**Subject: COLUMBIA GENERATING STATION, DOCKET NO. 50-397  
RESPONSE TO REQUEST FOR ADDITIONAL INFORMATION RELATED  
TO RELIEF REQUESTS FOR THE COLUMBIA GENERATING STATION  
FOURTH TEN-YEAR INTERVAL INSERVICE TESTING PROGRAM**

**RESPONSE TO REQUEST FOR ADDITIONAL INFORMATION RELATED TO RELIEF  
REQUESTS FOR THE COLUMBIA GENERATING STATION FOURTH TEN-YEAR  
INTERVAL INSERVICE TESTING PROGRAM  
ENCLOSURE 1**

**RP02  
Revision 1  
Relief Request  
in Accordance with 10 CFR 50.55a(f)(5)(iii)**

**RP03  
Revision 1  
Relief Request  
In Accordance with 10 CFR 50.55a(f)(5)(III)**

**SAMPLE DATA SHEET - Group A Test  
SW-P-1A ACCEPTANCE CRITERIA**

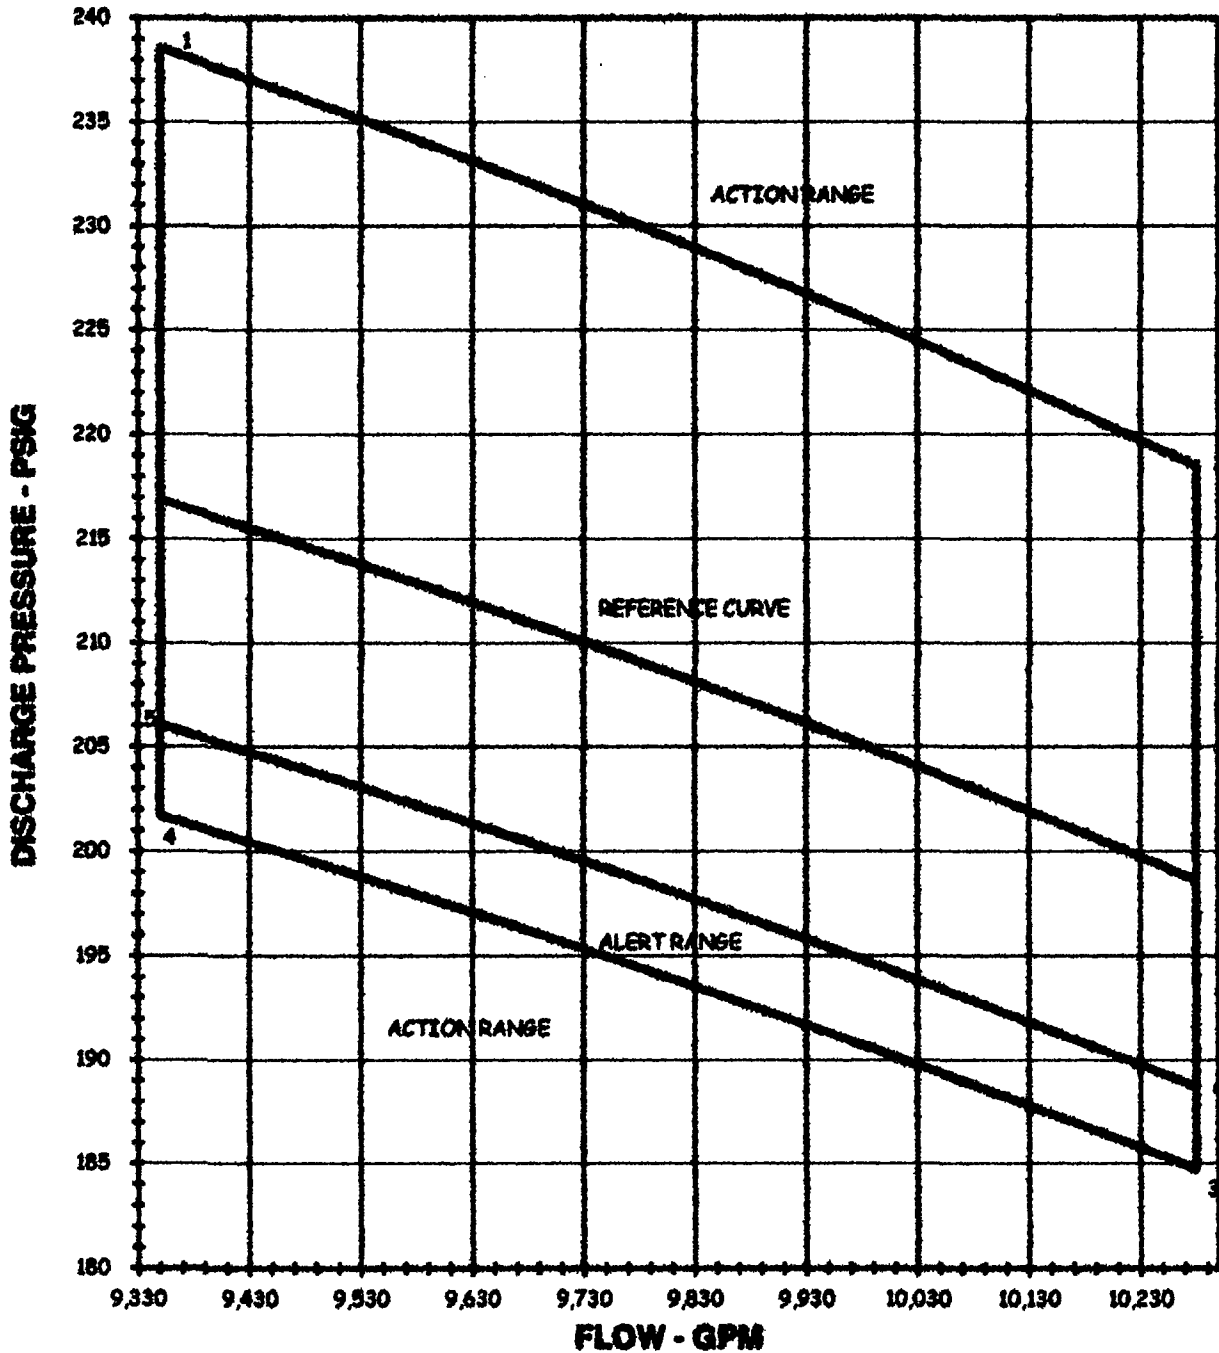
EPNB-RAI-RP-02-1: It appears that this alternative request is requesting the use of parts of Code Case OMN-16 for the standby service water pumps and the standby service water, HPCS pump. Please confirm if this is correct. If this is correct, please explain how your proposed testing differs from Code Case OMN-16 and provide justification for the differences.

The intent of Columbia Generating Station (Columbia) relief request RP02 is to follow all of the requirements of OM Code Case OMN-16. RP02 has been revised to clarify all the requirements specified in OM Code Case OMN-16 will be followed. Enclosure 2 contains Revision 1 to RP02.

4. The reference pump curves are based on flow rate vs. discharge pressure. Acceptance criteria curves are based on differential pressure limits given in Table ISTB-5121-1 for applicable test type. Setting the Code Acceptance Criteria on discharge pressure using differential limits is slightly more conservative for these pump installations with suction lift (Relief Request RP01). See the attached sample SW-P-1A pump Acceptance Criteria sheet for Group A test. Area 1-2-5-6 is the acceptable range for pump performance. Area 3-4-5-6 defines the Alert Range, and the area outside 1-2-3-4 defines the required Action Range.

6. Only a small portion of the established reference curve is being used to bind the flow rate variance due to flow balancing of various system loads. See the attached sample SW-P-1A pump Acceptance Criteria sheet for Group A test.

**SAMPLE DATA SHEET - Group A Test  
RHR-P-2A ACCEPTANCE CRITERIA**

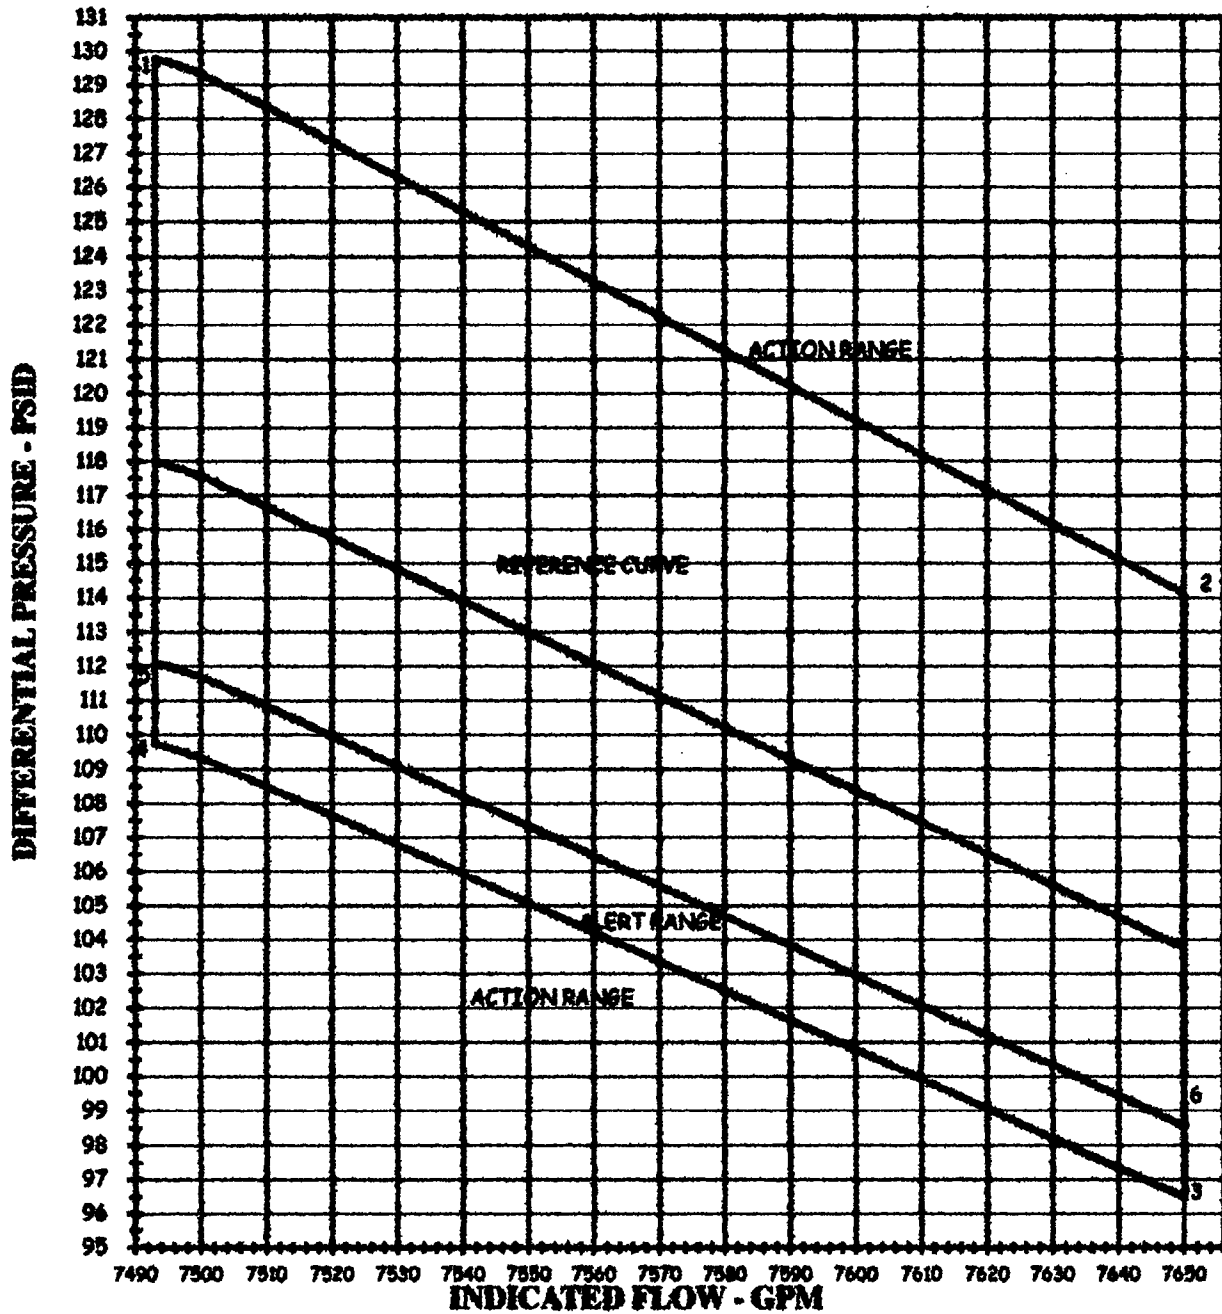
EPNB-RAI-RP-03-1: Relief request RP-03 lists several elements that are used to develop and implement the provided reference pump curves. Relief request RP-03

states that these elements "follow the guidance of Code Case OMN-16." Please clarify what portions of ASME OM Code Case OMN-16 are being followed. Also, please explain any deviations from ASME OM Code Case OMN-16 that are being requested in relief request RR-03.

Intent of Columbia relief request RP03 is to follow all the guidance of Code Case OMN-16 for testing of pumps LPCS-P-1, RHR-P-2A/B/C, HPCS-P-1 and RCIC-P-1. RP03 has been revised to clarify that all requirements of Code Case OMN-16 will be used for testing of these pumps. Enclosure 3 contains Revision 1 to RP03.

8. Acceptance criteria curves are based on differential pressure limits given in applicable Table ISTB-5121-1 or Table ISTB-5221-1. See the attached sample RHR-P-2A pump Acceptance Criteria sheet for Group A test. Area 1-2-5-6 is the acceptable range for pump performance.

Area 3-4-5-6 defines the Alert Range and the area outside 1-2-3-4 defines the required Action Range. A similar sample RCIC-P-1 pump Acceptance Criteria sheet for Group B test is also attached.
